ILLUSTRATIVE SITE DESIGNS
FOR
MULTI-FAMILY HOUSING IN PASADENA

Prepared for the Pasadena
Multi-Family Housing Task Force

Daniel Solomon and Associates
Daniel Solomon
Kathryn Clarke
Susan Haviland

DSA 48.13

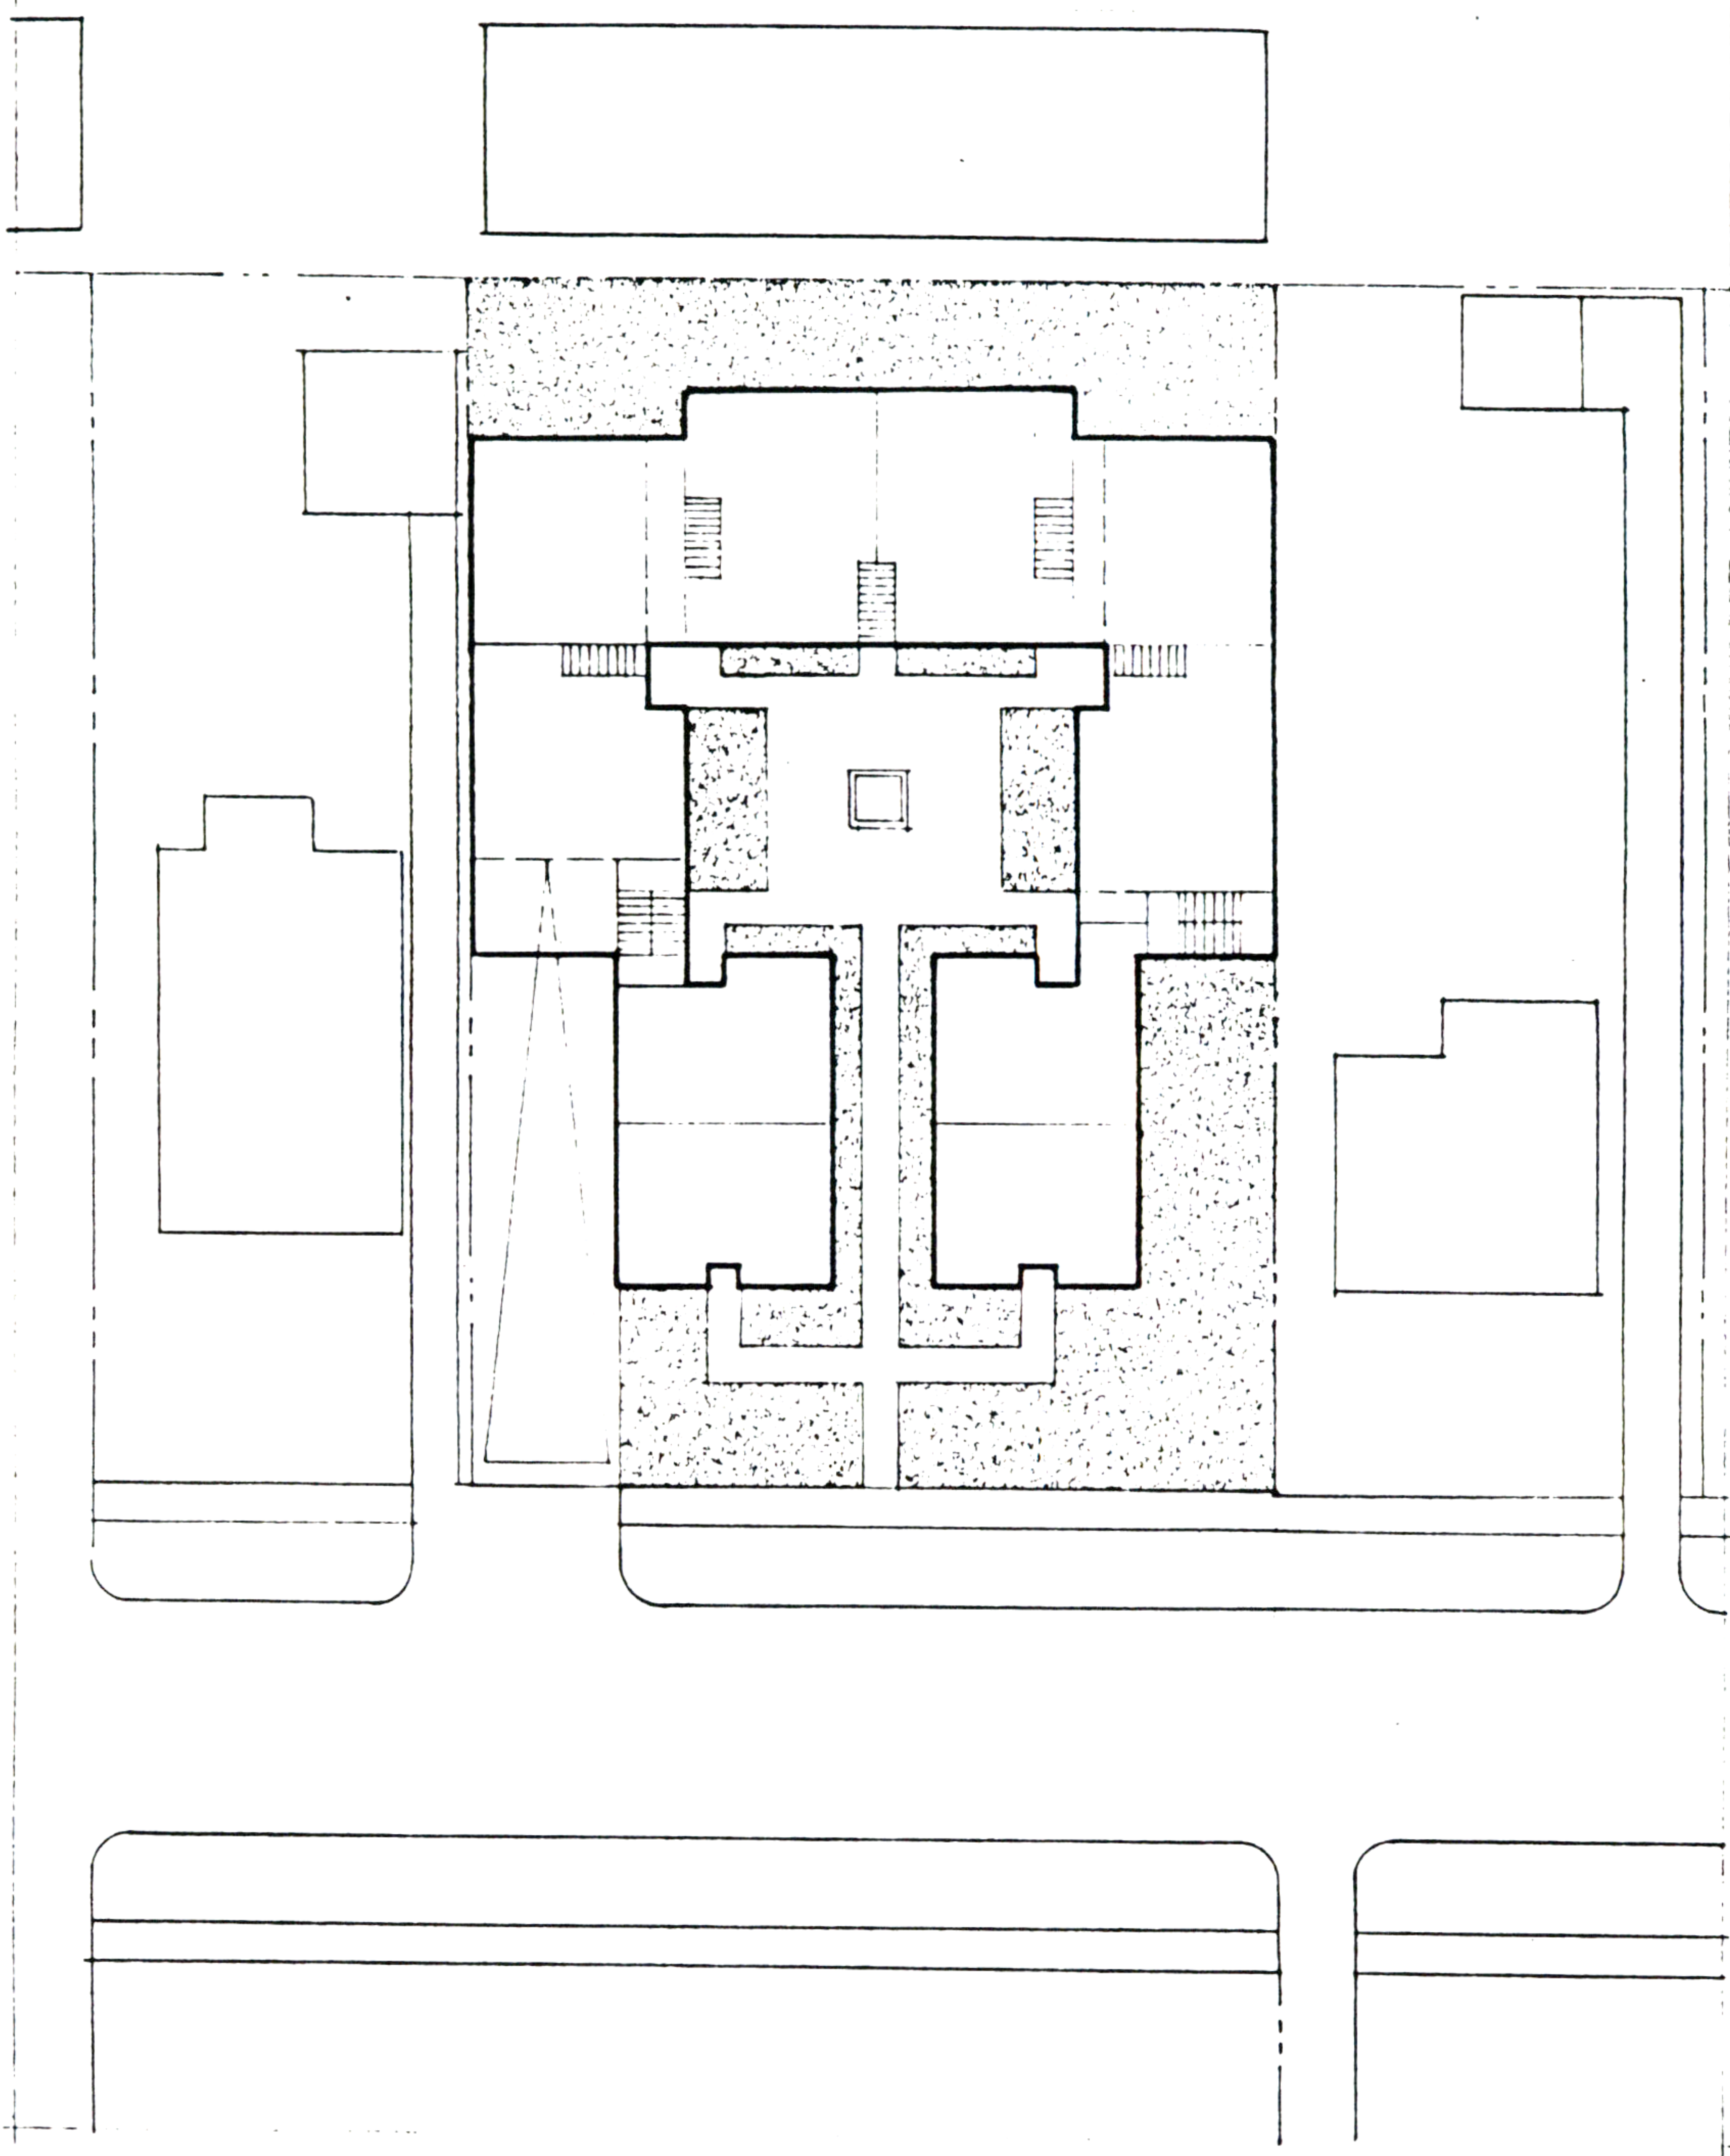
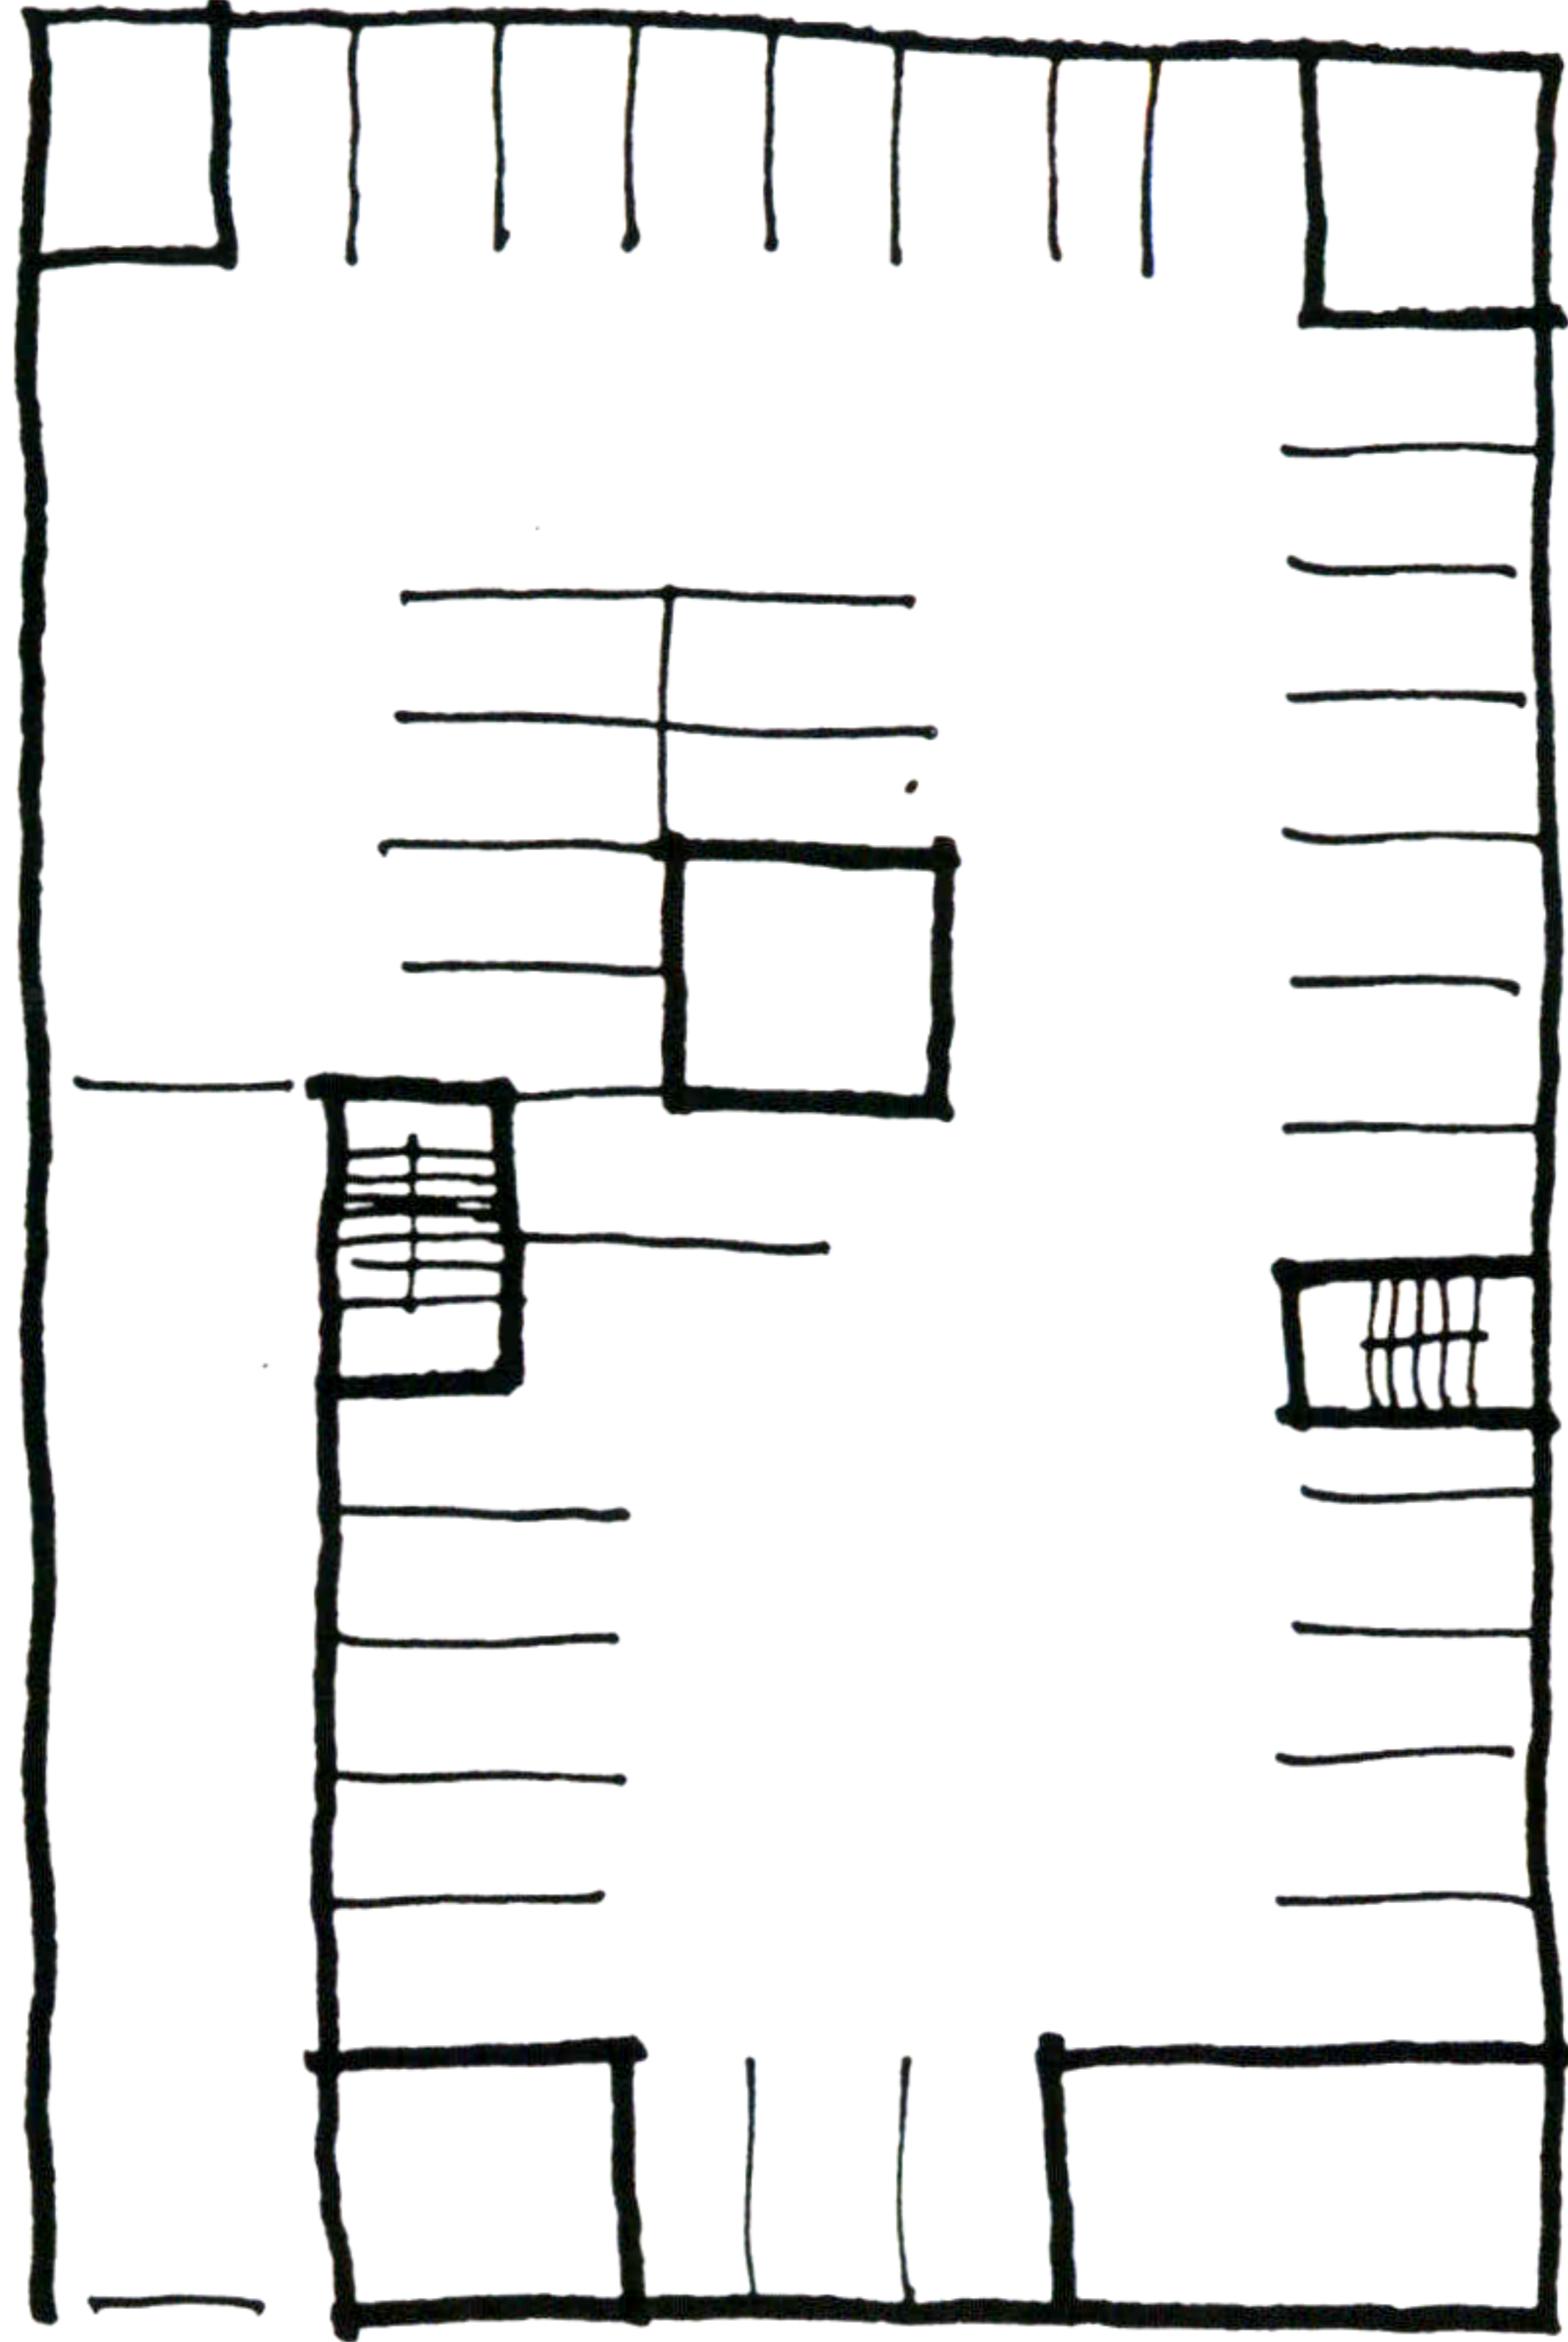
Fully Subterranean. Prefer Double Drive!

DSA 48.14

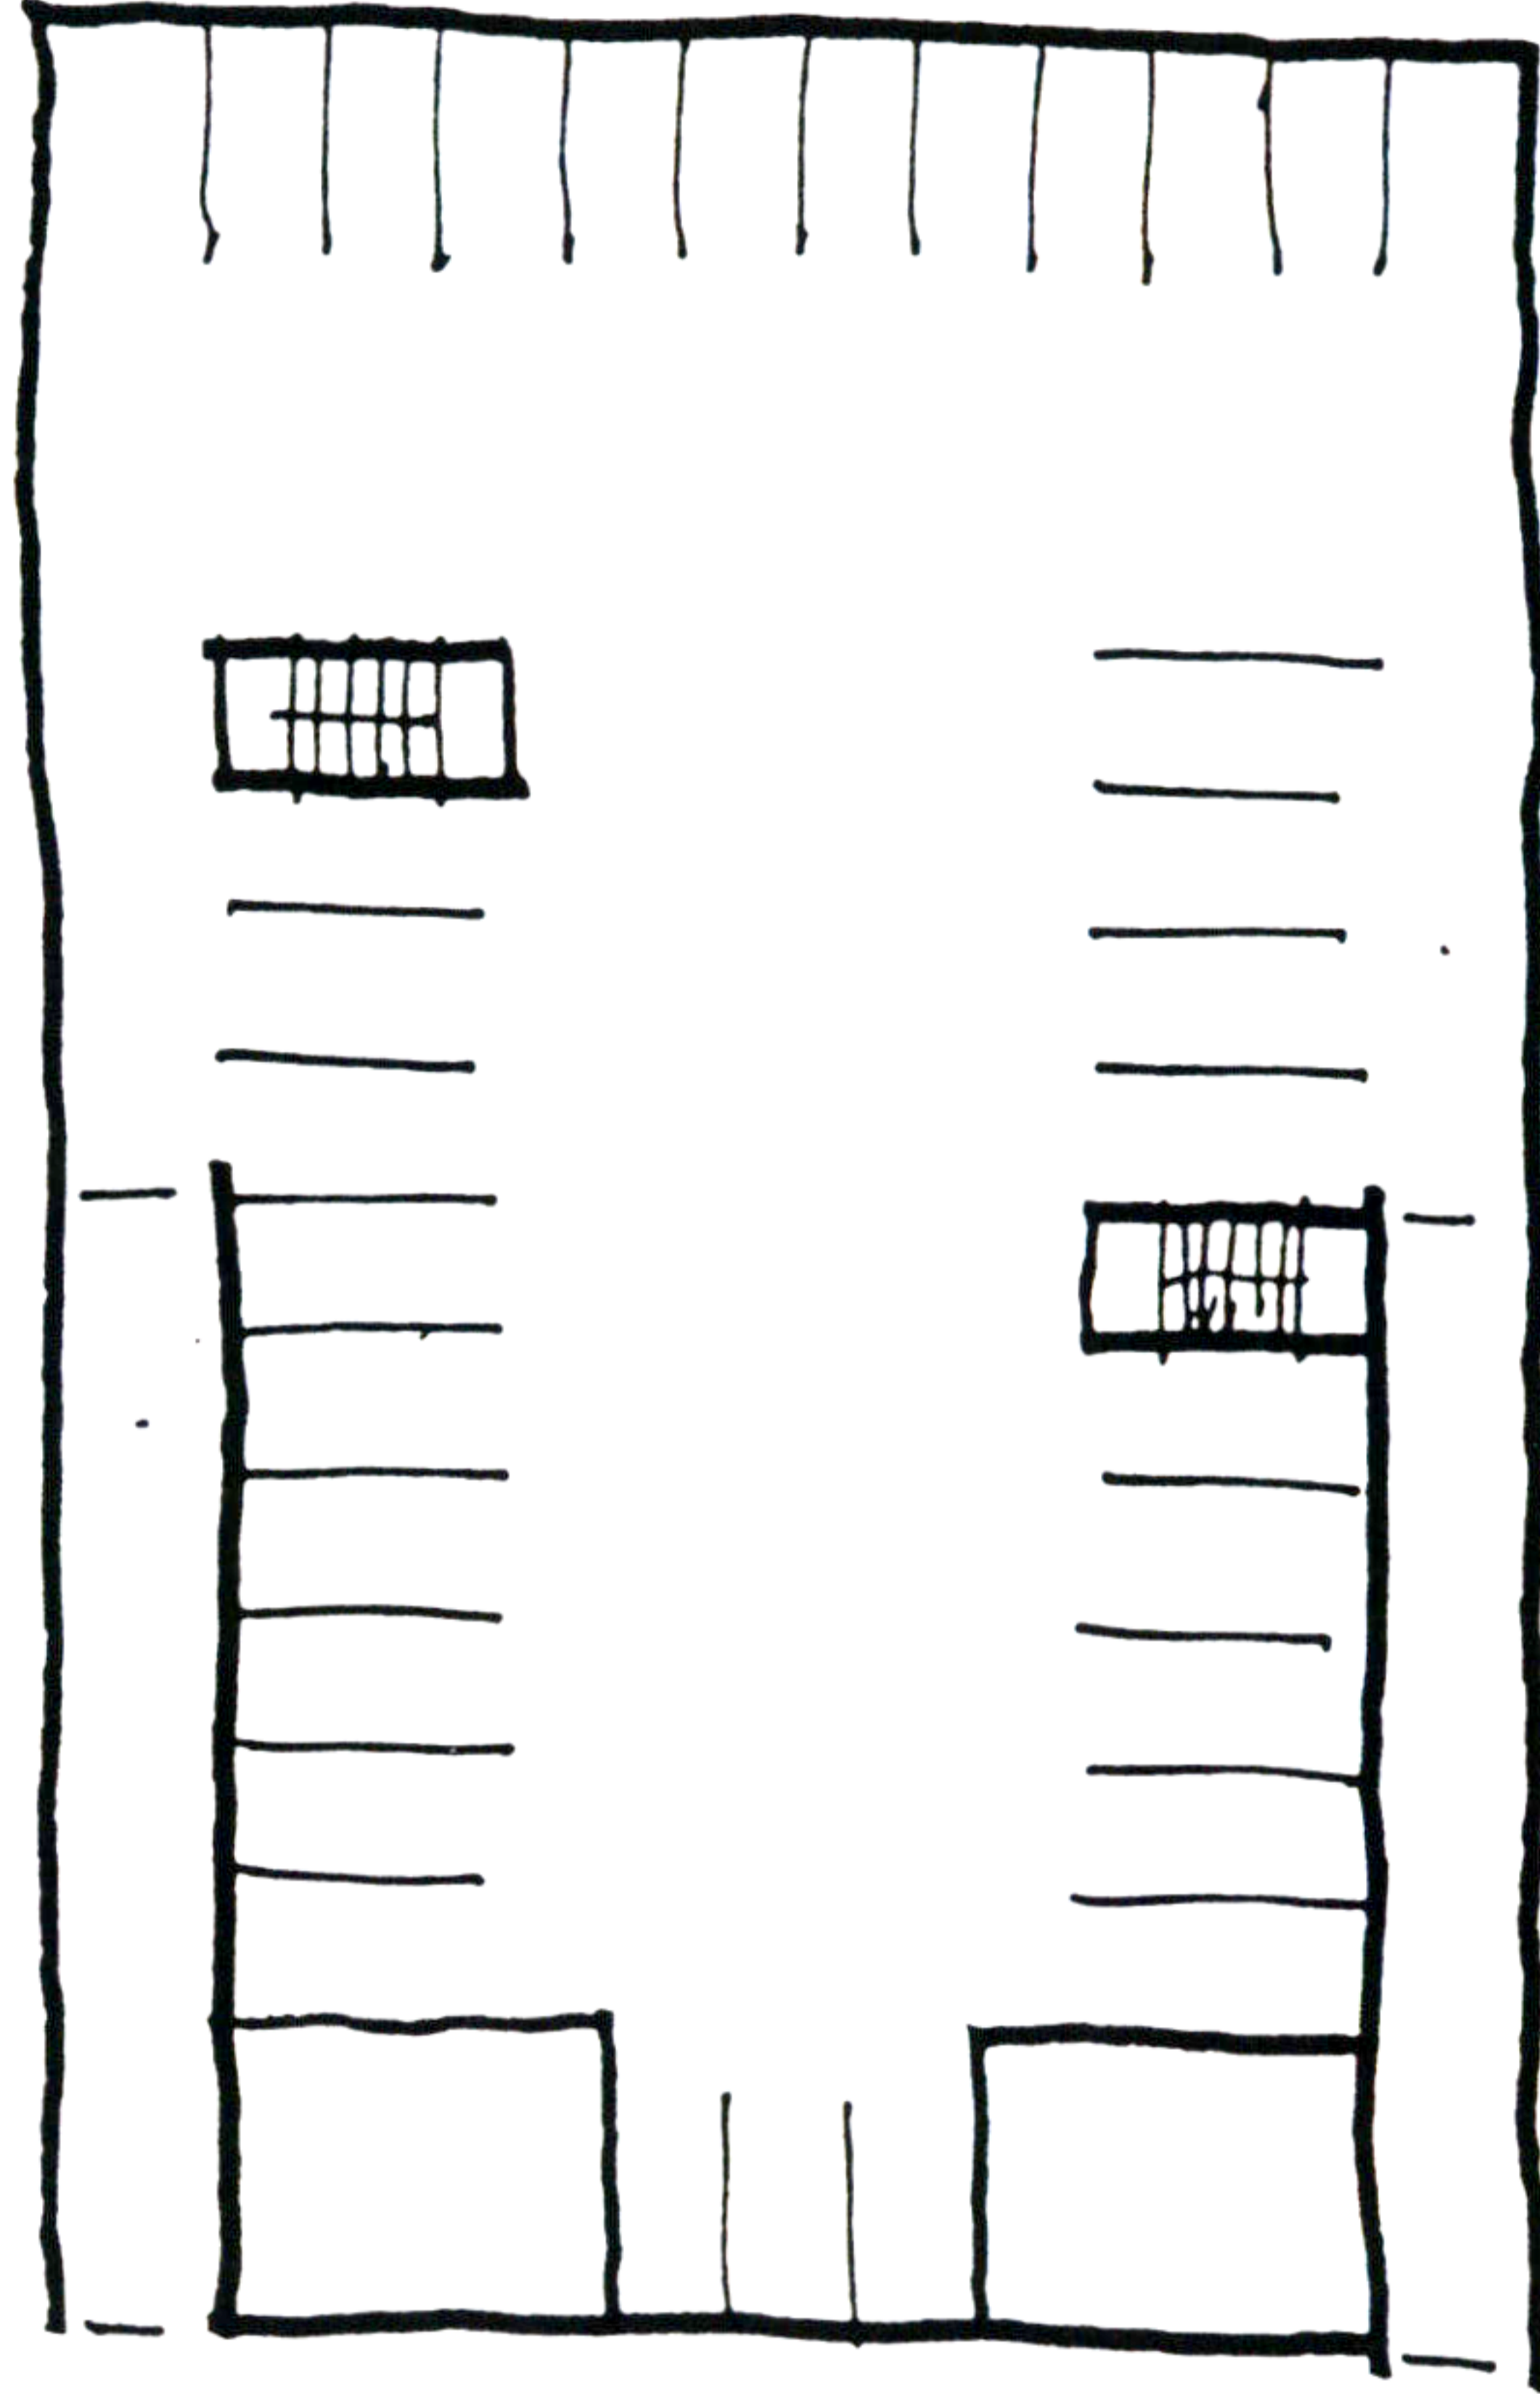
ONLY PARKING PLAN PROVIDED!
